Zoning & Subdivision Committee
Tuesday, September 6, 2016, 1:30 pm

Staff Report – Village Neighborhood Section 4 Phase 1

**Subject: Village Neighborhood, Section 4, Phase 1
Final Plat Review – Comment Letter #1**

**Subject: The Courtyards at Jerome Village, Phase 1
Final Plat Review – Comment Letter #2**

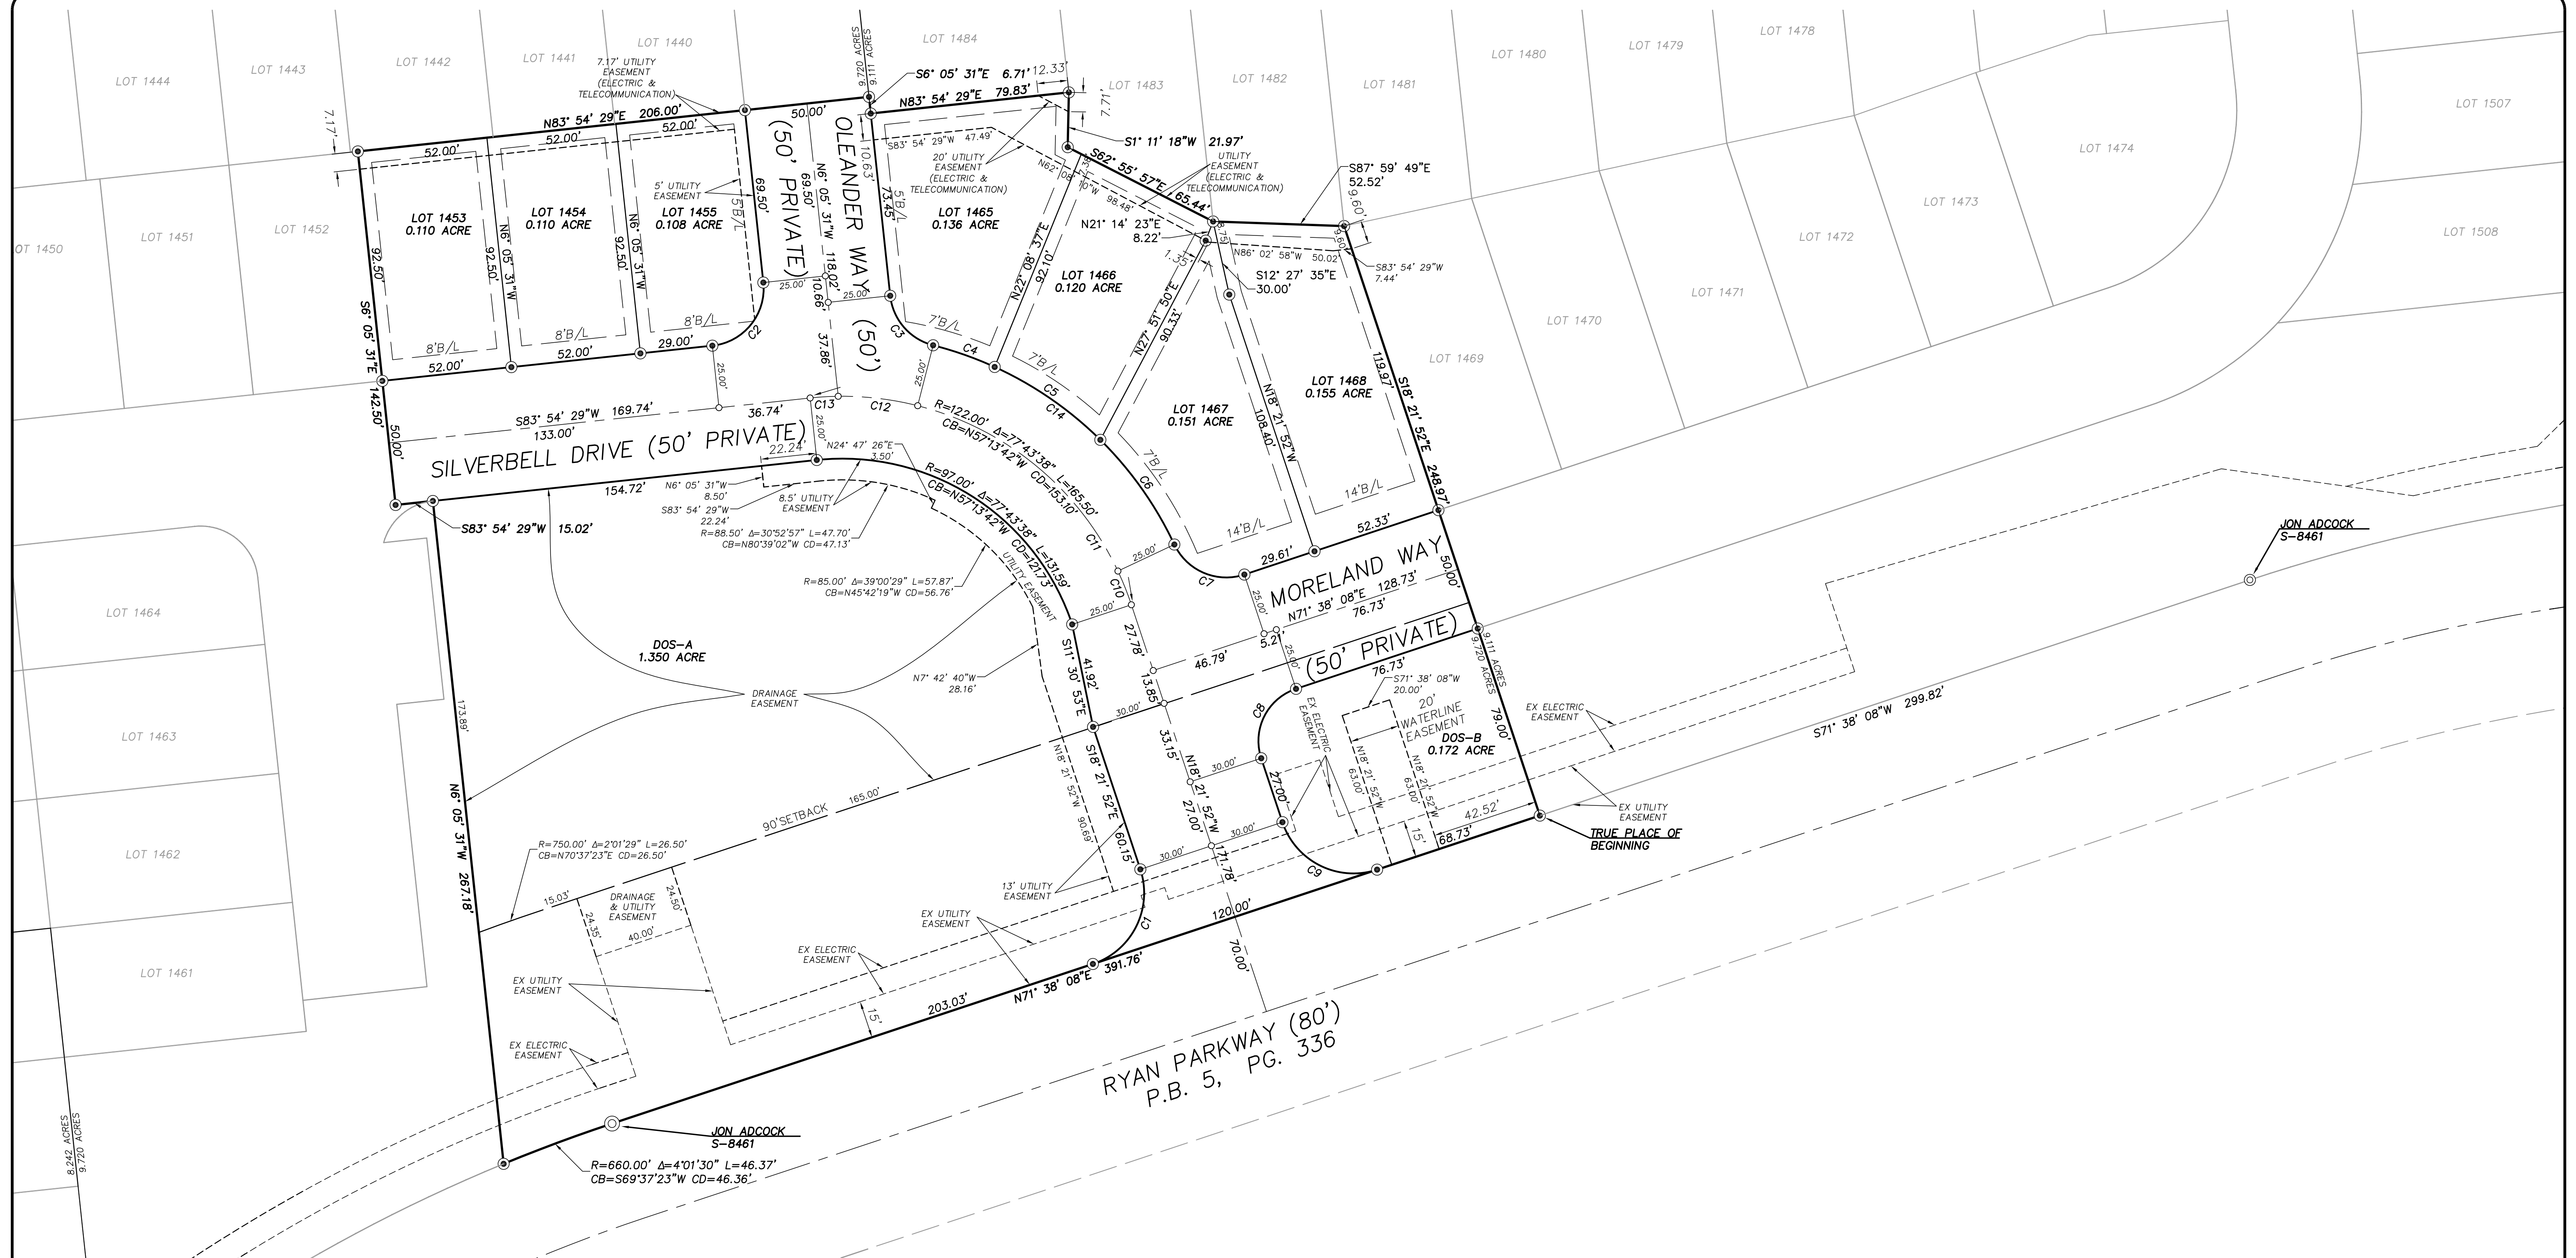
Union Rural Electric Cooperative has reviewed and noted comments per paper drawings received 08/22/16. Drawing set of 2 sheets issued as Amended Final Plat for The Courtyards at Jerome Village Phase 1 AKA Glacier Park Neighborhood Section 5 (GPN-5) Phase 1, Dated May 2016:

- 1) Sheet 1 of 2
 - a) Noted additional easement descriptions
- 2) Sheet 2 of 2
 - b) Noted additional specific utility easement descriptions.
 - c) Noted lot dimension changes.
 - d) Noted lot number changes.

1. Sheet 1: Define who uses the noted utility easements.
 2. Sheet 1: Request listing utilities and contacts using easement since two electric utilities are in the development. The different utilities could have conflicts when areas are not clearly defined.

3. Sheet 2: DP&L will serve lots 01 and 27. URE will serve lots 02 through 26.
 4. Sheet 2: URE request easement area that is closest to home locations.

5. Sheet 2: URE provided an easement clarification sheet to the applicant, requesting that the applicant make adjustments accordingly.
 6. Sheet 3: Add DP&L to notes “J” and “K”.

7. Sheet 3: Consider clarifying easement areas.

1. Sheet 1: The dedication note needs to match the required statements in Section 800 (§323, 14.; §800).
2. Sheet 1: The notarized certification reads Delaware County. Change to Union County (§323, 14.; §800).
3. Sheet 1: The notarized certification mentions Rockford Homes and this may be unintentional (§323, 14.; §800).

<ol style="list-style-type: none">4. Sheet 1/2: Correct acreage figures under Surveyor's Certificate and in the development summary. The figures do not match (§323, 1.).5. Sheet 1: Under Surveyor's Certificate, change from Part 1 to Phase 1 (§323, 13.; §800).6. Sheet 1: Update signatures to include "Approved this ____ day of ____, 2016: ____ County Commissioners." (§801).7. Sheet 2/3: Easements at back of lots are 10 feet. Note: The minimum width for water/sewer lines is 20 feet. The applicant was advised of this during the Preliminary Plat approval (§414).8. The most southern street is labeled Jeffrey Pine Drive on the proposed Final Plat, but it is labeled Orange Drive on the Preliminary Plat (§323, 5.).9. A letter from the County Engineer verifying all required improvements have been installed and approved by the proper officials or agencies, or verifying a bond or other surety, approved by the County Commissioners and their legal counsel, has been furnished assuring installation of the required improvements" (§324, 2.; §326; §330).

PLAT
SHEET 2 OF 3

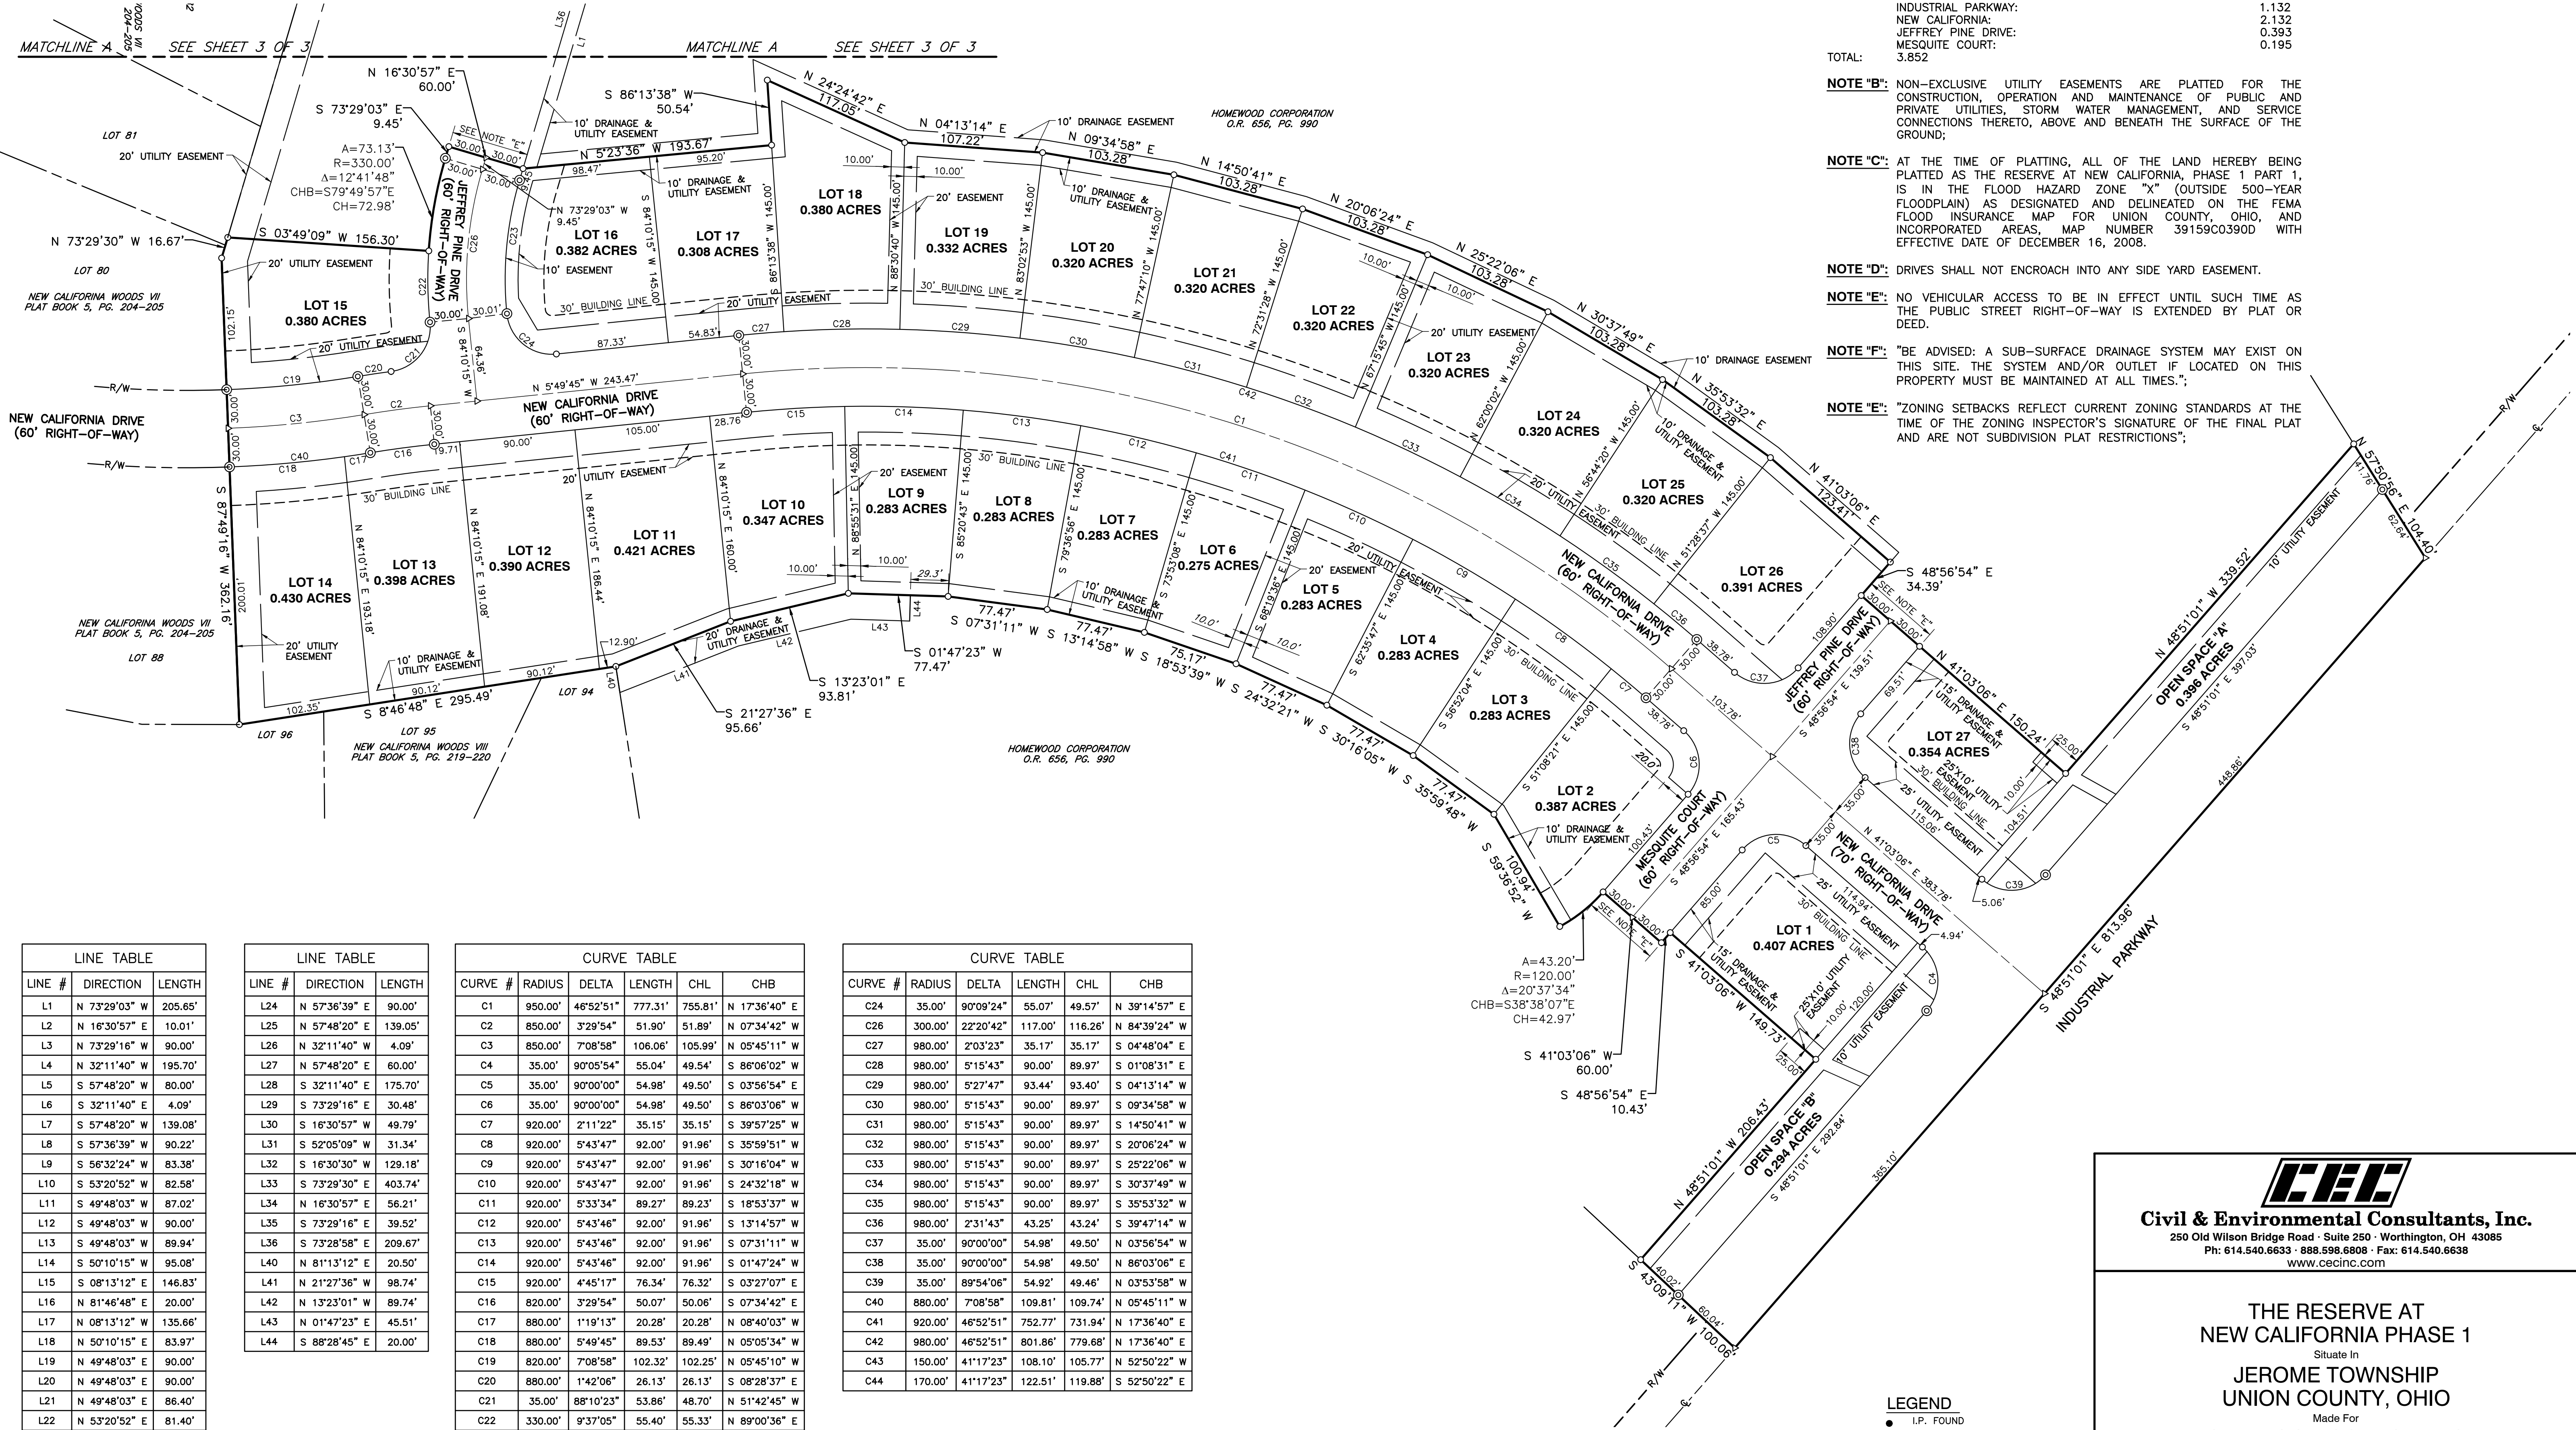
- 1) Sheet 1 of 3 – Plat
 - a) Need to define who uses the noted utility easements for clarity.
 - b) Request listing of utilities and contacts using easement since two electric utilities are in the development. The different utilities could have conflicts when areas are not clearly defined.

- 2) Sheet 2 of 3 – Plat
 - c) URE has a territory split with DP&L. DP&L will serve lots – 01 and 27. URE will serve lots 02 through 26
 - d) URE electric services is from rear lot. URE request easement area that is closest to home locations.

- e) Reference separate attached document "The Reserve at New Ca Phase 1-URE Easement Clarification 08-31-16" that has clarification of easement and road crossing locations. Highlighted and noted from sheet 2 of 3.

- f) Typically phone and or cable or fiber will go joint use with URE trenching.
- 3) Sheet 3 of 3 – Plat
 - g) Need to edit NOTE "J" and "K" to include DP&L as electric power provider.
